T ECHNICAL INFORMATION

63825

Subject ▶ Change of Pin 4 and Sleeve

For Models ▶ 6827

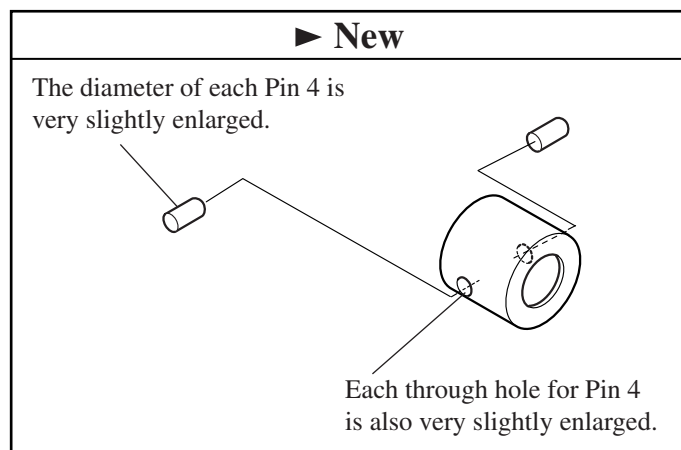
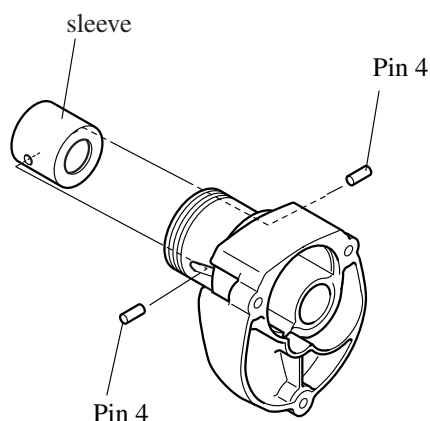
Item No.	Current part		Q'ty	I/C	New part		Q'ty	Note
055	Pin 4		2	→	Pin 4		2	See below for detailed information of interchangeability.
056	256226-4				268075-7			
060	Sleeve		1	←	Sleeve		1	
	324141-1				324209-3

Sleeve	
		the current one (Part No.324141-1)	the new one (Part No.324209-3)
Pin 4	the current one (Part No.256226-4)	Yes	Yes
	the new one (Part No.268075-7)	No	Yes

From Apr. 2001
